Z-80 CPU

Z80 BOARD, REVISION 2

Revision A

May 17, 1979

Silk Screen Incorrect

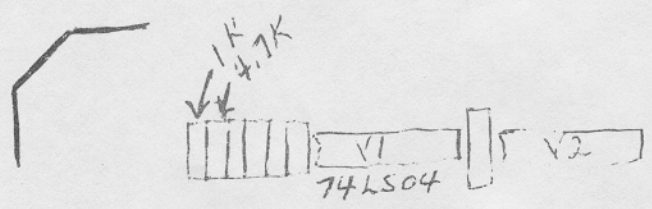
The 4.7K resistor in the upper left hand corner should be 1K.
The 1K resistor to the right of it should be 4.7K.
